THE CLEVELAND ELECTRIC ILLUMINATING COMPANY

Perry Nuclear Power Plant
Docket Nos. 50-440; 50-441
Response to Request for
Additional Information -
Geology-Seismology

This letter and its attachment is submitted to provide draft responses to the additional questions raised by Dr. Ibrahim on the geology-seismology of the Perry Nuclear Power Plant. Enclosed is a new response for question 230.3 which supercedes the old response. Supplemental information is provided for question 230.6 in addition to the response previously provided.

Figure 20

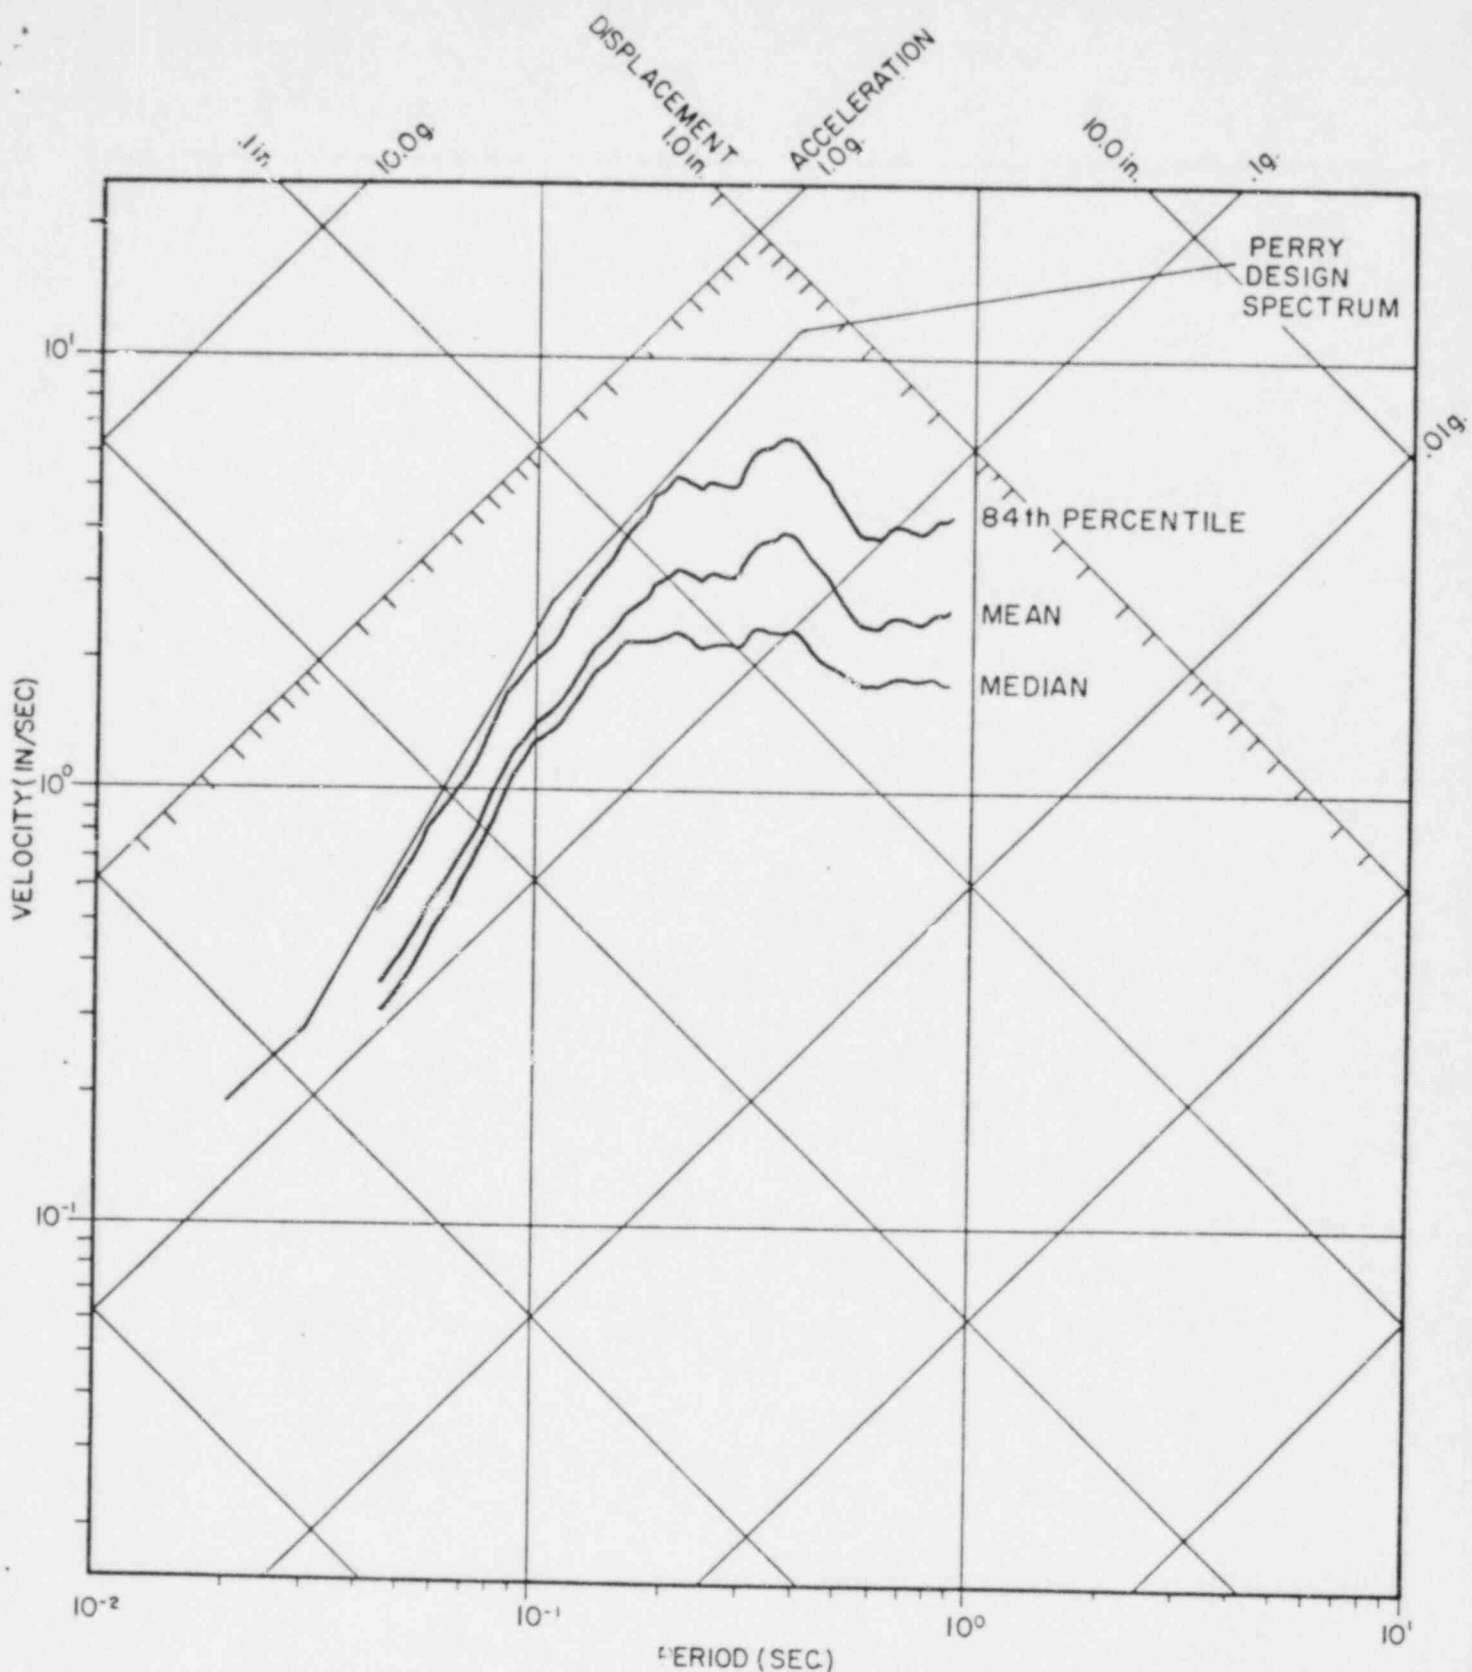
Three additional sensitivity tests have been run for the purpose of confirming the consistency of the results and illustrating the fact that the Parkfield earthquake is an anomalous event. Tables 1 and 2 (revised) present all relevant data. Figure 20 shows the response spectra obtained whenever two components from the Temblor Station (Parkfield earthquake) are included. The 84th percentile peak acceleration increases from 98.9 cm/sec^2 to 153.3 cm/sec^2 , and the spectral level is considerably raised over the entire period range. Figure 21 and 22 show the response spectra obtained when two events of $M_L=6.0$ and three events of $M_L=6.0, 6.0$ and 6.1 are added to the basic subset. As shown on Table 2 (revised), the peak acceleration at the 84th percentile is very similar, i.e. 133.0 and 131.6 cm/sec^2 . The spectra are almost identical. The interesting point to be noticed is that these spectra are lower than those obtained with the inclusion of the Temblor components to the basic subset, although they include the contributions of events of $M_L=6$ level. These sensitivity tests suggest that the Parkfield data obtained at Temblor might indeed correspond to a much higher magnitude level ($M_L=6.4$ and 6.7) as calculated by Kanamori and Jennings. On that basis, these records would not be acceptable to model the design earthquake $m_b=5.3$.
